New Bedford Harbor Superfund Site

Addendum to the Final Aerovox Interim Sediment Cap 100% Design Plan

ACE-J23-35BG2000-M1-0042| 0

Appendix A – Response to Comments

Asphalt Protection System	
AEROVOX INTERIM SEDIMENT CAP	
NEW BEDFORD HARBOR SUPERFUND SITE NEW BEDFORD, MASSACHUSETTS	
 SEVENSON ENVIRONMENTAL SERVICES, INC.	
DRAWING	DATE: 9-05-18
1	DRAWN BY: APM
	CHECKED BY: DEF
	CAD FILE: PAD PROGRESS 9-05-18
	SCALE: AS SHOWN

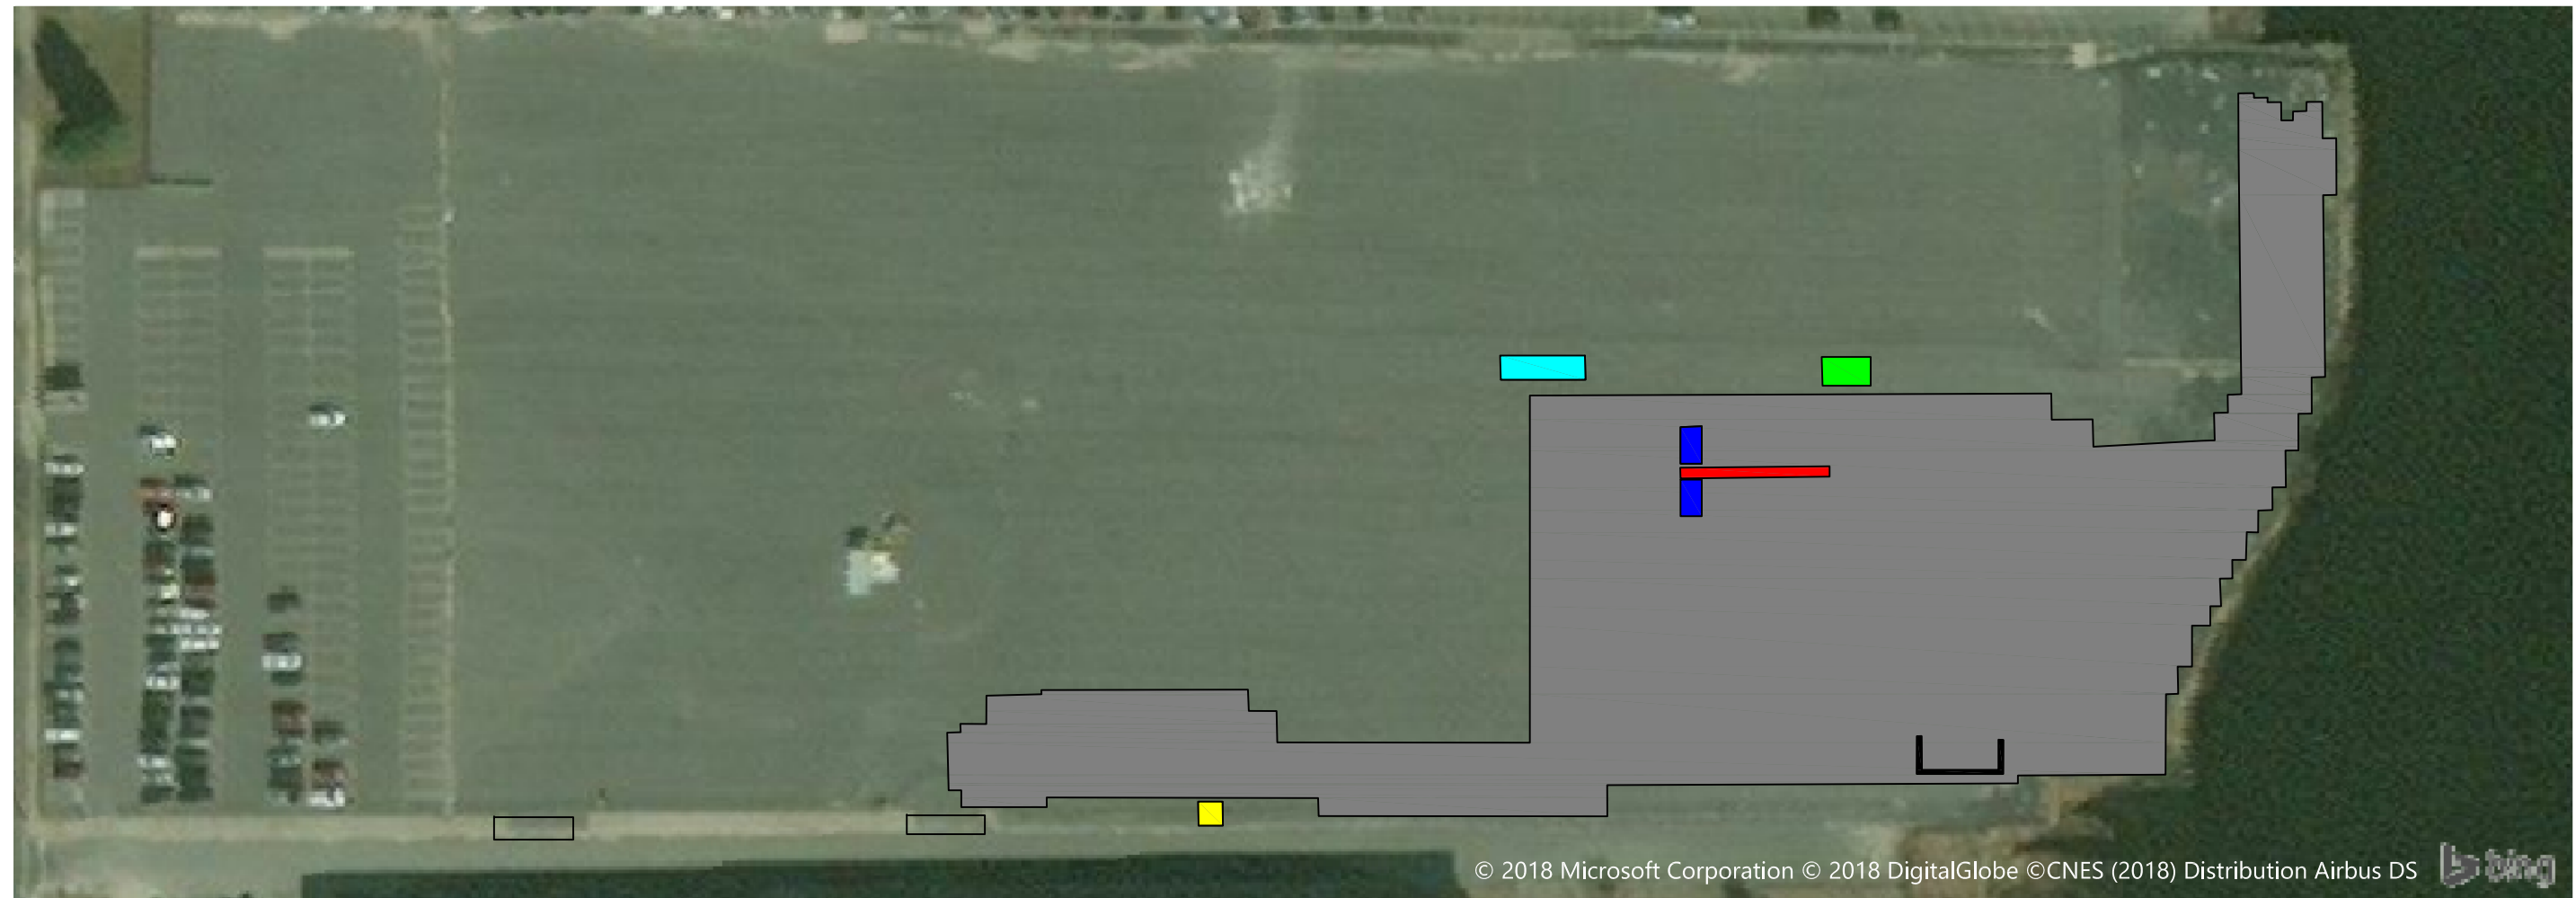
- 4) **Comment:** It appears, based on the figure, that mats will be placed along most of the sheet pile wall. Will the mats directly abut the sheet pile wall for the roadway? A more detailed/closer view figure is needed.

Response: The mats will not directly abut the sheet pile wall in all locations. The mats will be as close as we can physically place them based on geometry of the wall. See Figure 1 of the Addendum to the Final Design Plan demonstrating the mat locations as installed.

Figure 2

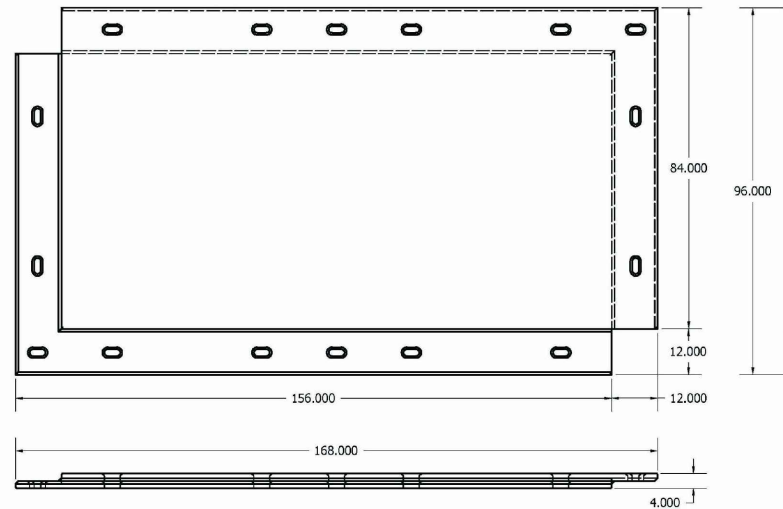
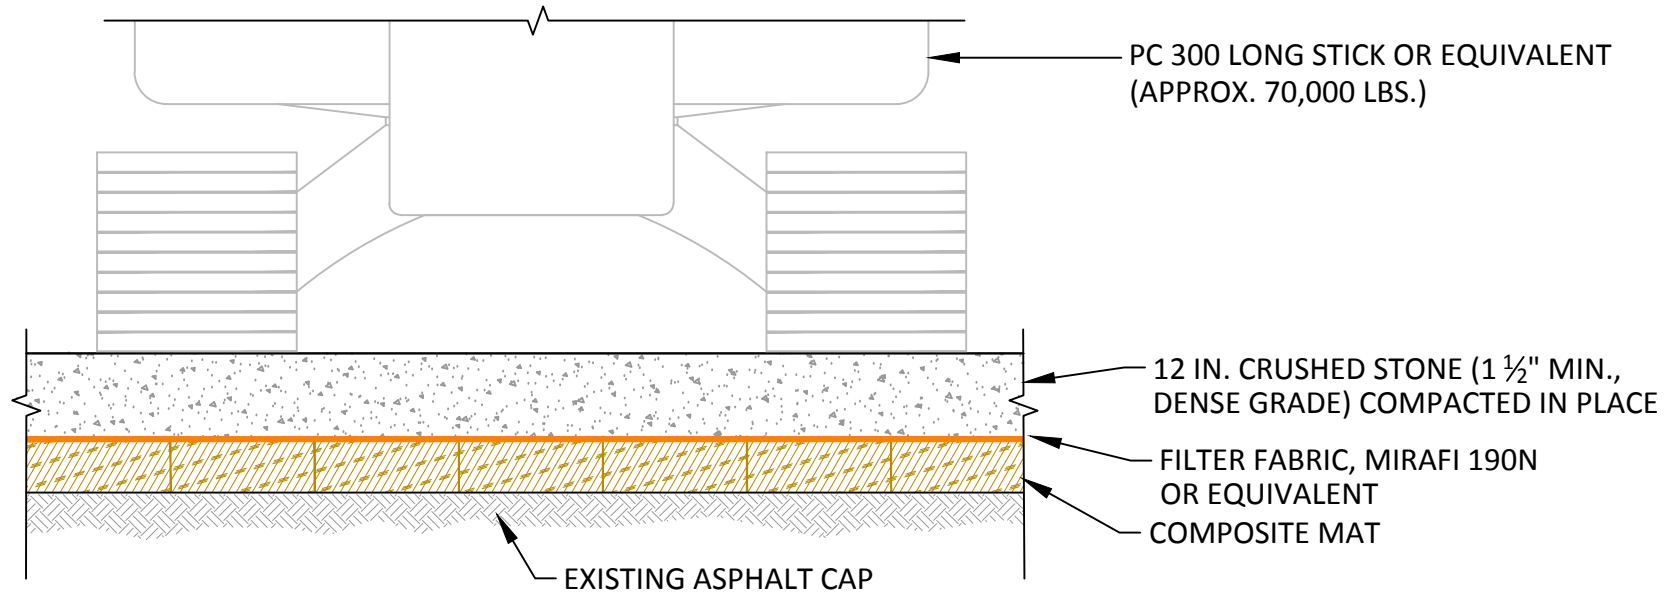
- 5) **Comment:** Confirm plans for placement of filter fabric, crushed stone and composite mats along the shoreline area. Figure 21 (100% design) shows excavator for shoreline area placement of cap with treads directly in contact with composite mats, but recent Jacobs discussions indicate that crushed stone or gravel would be placed on top of composite mats. What is proposed under this modified approach?

Response: The modified approach will also use geotextile, mats, and crushed stone system to protect the Aerovox cap system. The layer sequence from bottom to top will be geotextile, mat, geotextile, crushed stone. See Figure 2 of the Addendum to the Final Design Plan.

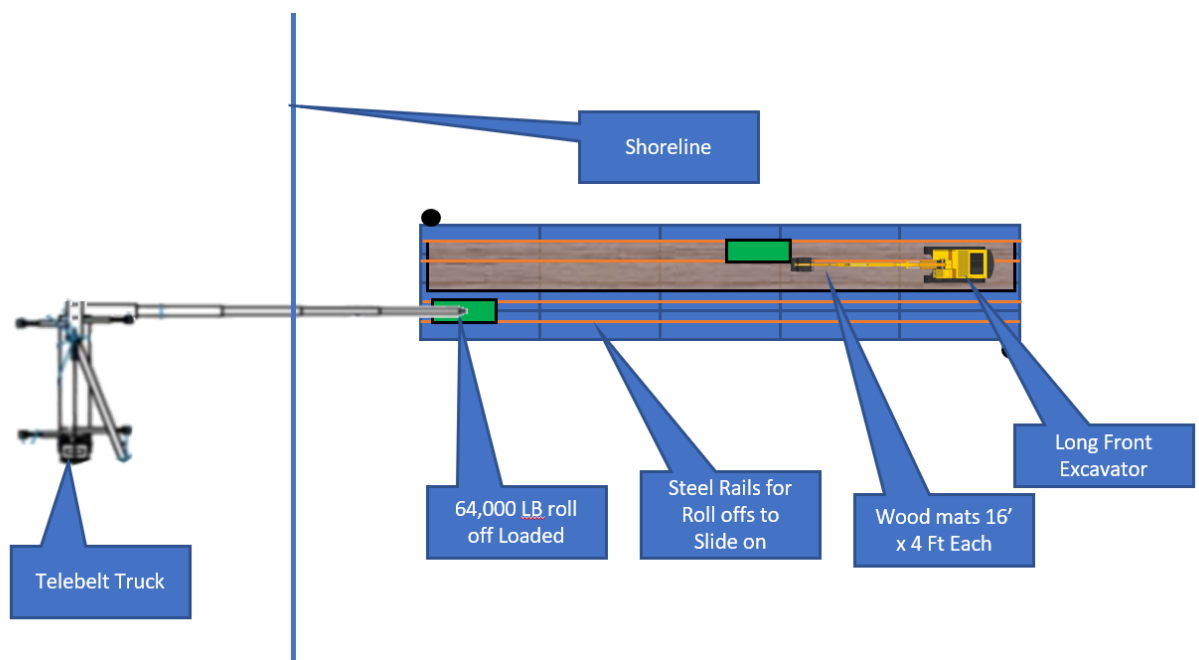
- 2) **Comment:** Is there any potential for conveyer vibration to separate the clay from the sand during transit? Is the conveyor covered (e.g., on windy days will sand and/or clay be blowing off the conveyor during transit to the roll-offs)?

Response: Severson intends to keep the materials damp to minimize dust (see photo below). The misting system was used recently on the Gowanus Canal Superfund Site. We do not foresee belt vibrations being an issue. Severson has used conveyors and hoppers for blending operations in the past without any trouble. Note that the misting application will only occur on the organo clay and sand blending or the material piles. The Telebelt conveyor belt will not be misted due to potential performance issues.

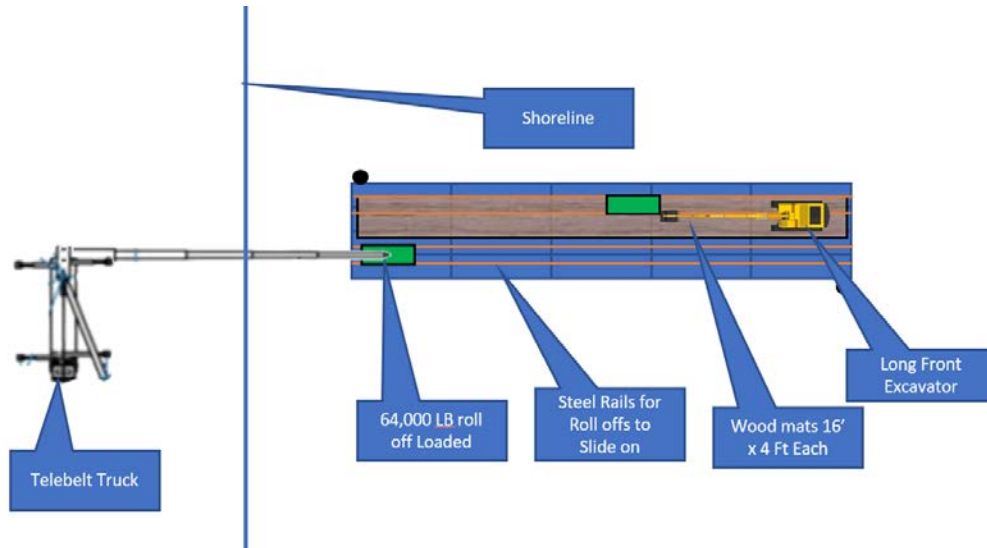
- 3) **Comment:** Are any tracking problems of the roll-off boxes anticipated across the travel path on the barges, that may necessitate rails of some sort?

Response: Steel C channel rails will be staged to avoid the tracks of the excavator (orange lines below). Details are below.
